Ministry of Power

Northern Regional Power Committee

Subject: Minutes of 40th Protection Sub-Committee Meeting.

Minutes of 40th Meeting of Protection Sub-committee

POWERGRID details

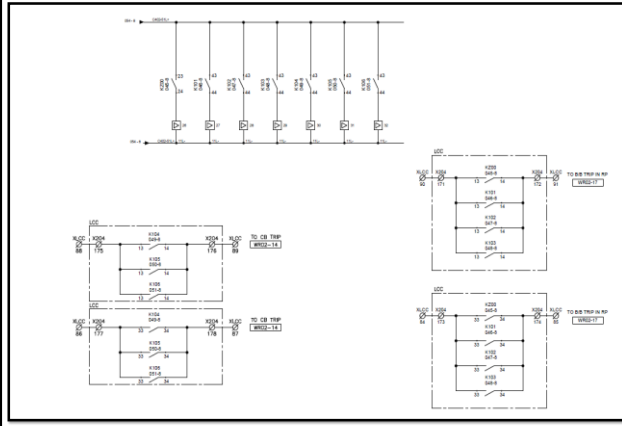
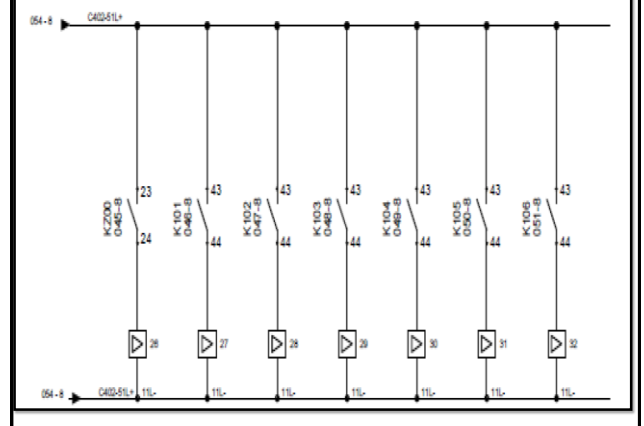
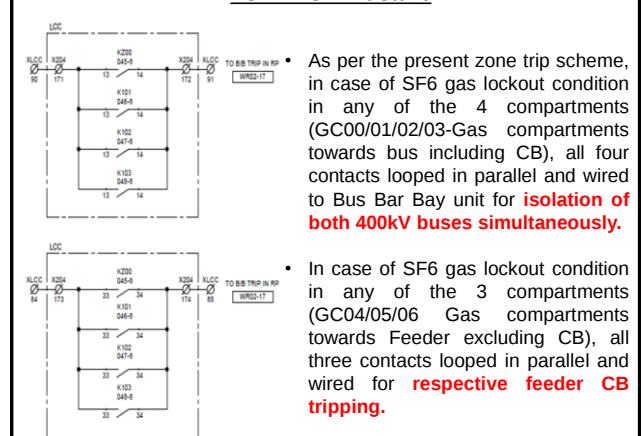
In typical 400kV lines (Say Neemrana-1) total 07 no. SF6 Gas Zone trip contactors are available

- The Contactor has been replaced and, the matter is in discussion with GIS manufacturer to rectify the same and to avoid any such incidence in future.
- The protection scheme is being modified such that-
 - Remove the looping of 4 contacts of KZ00, K101, K102, K103.
 - Parallel the contact of only 2 contactor of KZ00 and K103, wired to bus bar bay unit and configure for tripping of bus bar based on bus isolator status.
 - Parallel the contact of contact of K101 for all 400kV feeders and wired to bus bar central unit for tripping of 400kV Bus Bar-1.
 - Parallel the contact of contact of K102 for all 400kV feeders and wired to bus bar central unit for tripping of 400kV Bus Bar-2.

M2 DR of 220 kV Wagoora PG (end)-Pampore ckt-2

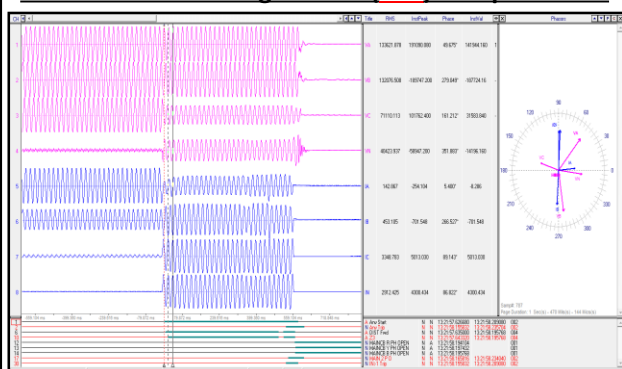
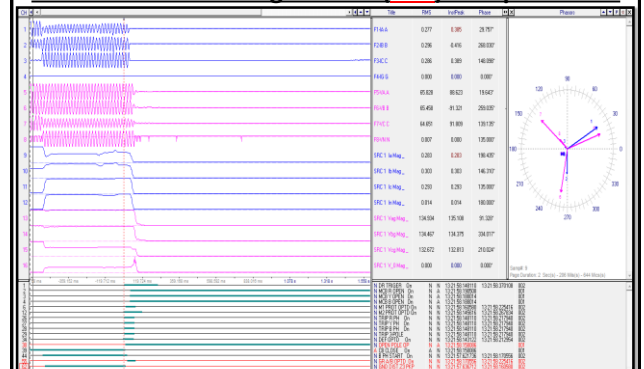
M-2 operated on DEF (directional earth fault protection). Sensitive DEF setting needs to be looked into.

Pre fault CB Position

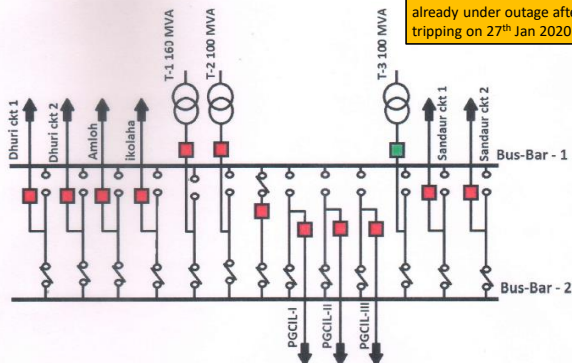
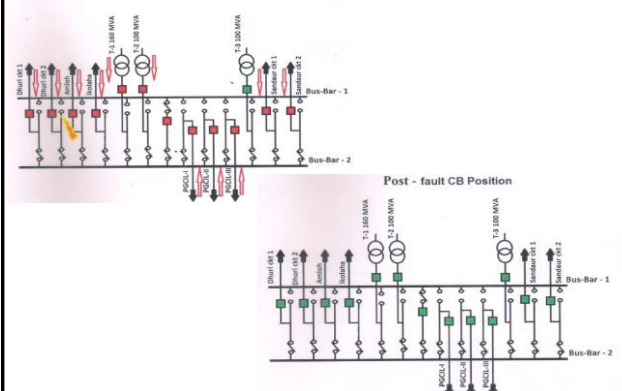
220 kV bus bar-1 was already under outage after tripping on 27th Jan 2020

As per PMU, SCADA data:

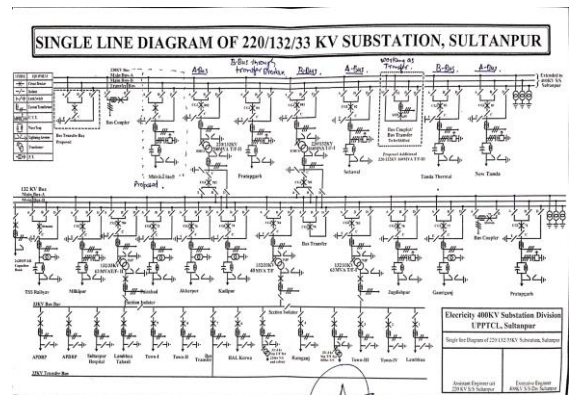
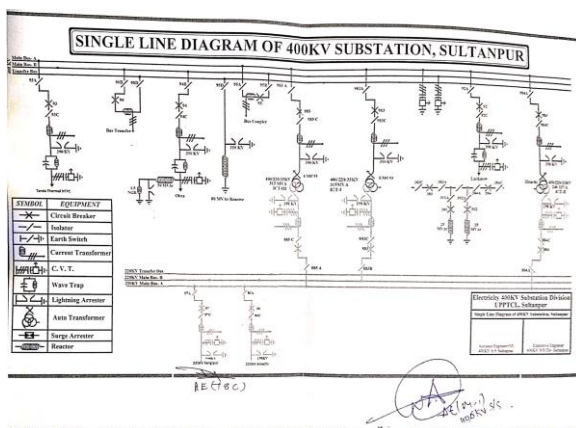
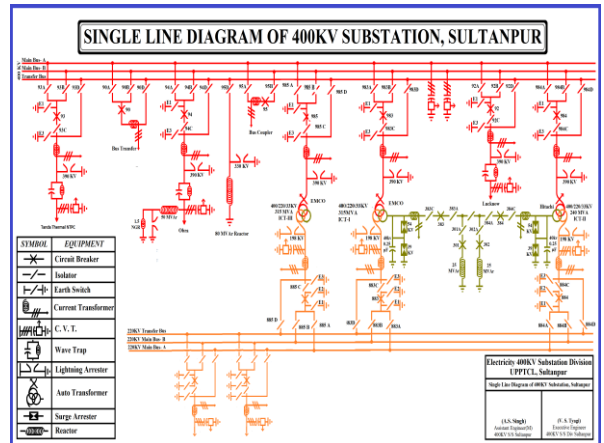
- As per PMU, R-phase to earth fault.
- Fault Clearance time: **2320ms**
- SoE didn't capture for any of the tripped elements.
- SCADA digital status for 400/220kV Malerkotla(PG) & Malerkotla (Punjab) was not available in POWERGRID & Punjab SoE.
